Item ID: D206-667-207BL Accept ***N900040100*** Setup Start ***NS1***
 Revision ID: Stop ***NS2***
 Item Name: Aft Crosstube - Mid Height 206L / L1 / L3 / L4, Blue
 Start Date: 6/16/2017 Start Qty: 1.00 ***1*** Cust Item ID:
 Required Date: 7/5/2017 Req'd Qty: 1.00 ***1*** Customer:
 Reference:

DART AEROSPACE LTD		Work Order: 162194
Description: Crosstube Mid Aft (206L)		Part Number: D206-667-207
Inspection Dwg: D206-667-247 Rev: A		Page 1 of 1

DART AEROSPACE LTD HAWKESBURY, ONTARIO, CANADA	
DRAWING NO. D206-667-247	REV. A SHEET 1 OF 4
TITLE CROSSTUBE ASS'Y (206L MID AFT)	SCALE NTS

DRAWING NO. D206-667-247	TITLE CROSSTUBE ASS'Y (206L MID AFT)	REV. A	DART AEROSPACE LTD ENGINEERING ORDER		D.E.O. NO. D206-667-247-A-1	SHEET NO. SHEET 1 OF 1	SCALE NTS
DRAWN <i>q</i>	CHECKED <i>ASS</i>	MFG. APPR. <i>AD</i>	APPROVED <i>JMP</i>		DE APPR. <i>th</i>		
DATE 11.07.15	DATE 11.07.20	DATE 11.07.21	DATE 11/07/21		DATE 11.07.21

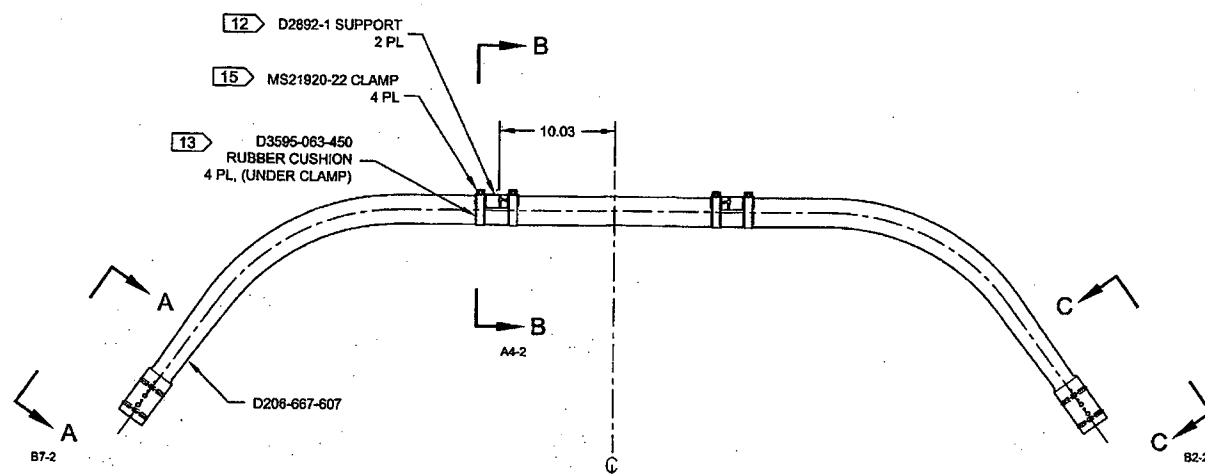
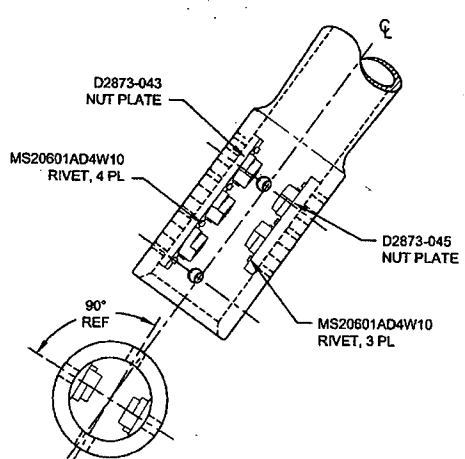
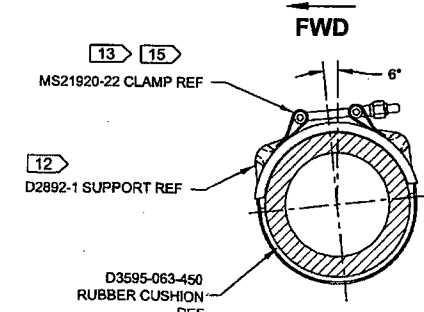
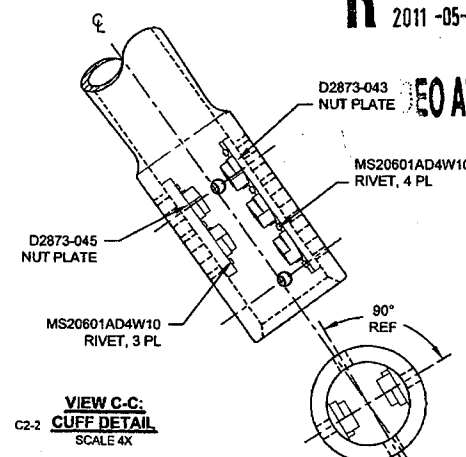
PURPOSE:

REPLACE MAGNOBOND WITH PROSEAL

IS:

Item	Qty -247	Part Number	Description
9	A/R	PROSEAL 890 B-2	SEALANT, AMS-S-8802 CLASS B-2

WAS:

9	A/R	MAGNOBOND 6398	ROCKWELL SPECIFICATION RBO-120-023 ADHESIVE (TEXTRON/BELL SPEC. 299-947-100, TYPE II, CLASS 2 ADHESIVE)
---	-----	----------------	---

NOTE 12 & 15, SHEET 1 IS AMENDED AS FOLLOWS:

WAS:

- 12) INSTALL D2892-1 SUPPORT USING 0.03" TO 0.06" THICK LAYER OF MAGNOBOND 6398 PER QSI 015. LET CURE FOR 12 HOURS AFTER INSTALLATION AND PRIOR TO PACKAGING.
- 15) TORQUE CLAMPS 80 TO 100 IN-LB. ENSURE AT LEAST 1.5 THREADS SHOWING IN SAFETY AND THAT NUT HAS NOT BOTTOMED-OUT AFTER TORQUING.

IS:

- 12) TO INSTALL D2892-1 SUPPORT: ABRASE MATING SURFACE OF SUPPORT AND CROSSTUBE WITH 180-GRIT SANDPAPER AND REMOVE RESIDUE WITH MEK (OR EQUIVALENT). APPLY A 0.04" TO 0.07" THICK LAYER OF PROSEAL 890 CLASS B-2 (OR AMS-S-8802 CLASS B-2) SEALANT TO MATING SURFACE OF SUPPORT.
- 15) TORQUE CLAMPS 80 TO 100 IN-LB. ENSURE AT LEAST 1.5 THREADS SHOWING IN SAFETY AND THAT NUT HAS NOT BOTTOMED-OUT AFTER TORQUING. **PRIOR TO PACKAGING, RE-CHECK TORQUE ON CLAMPS AFTER PROSEAL 890 SEALANT HAS CURED FOR 72 HOURS.**
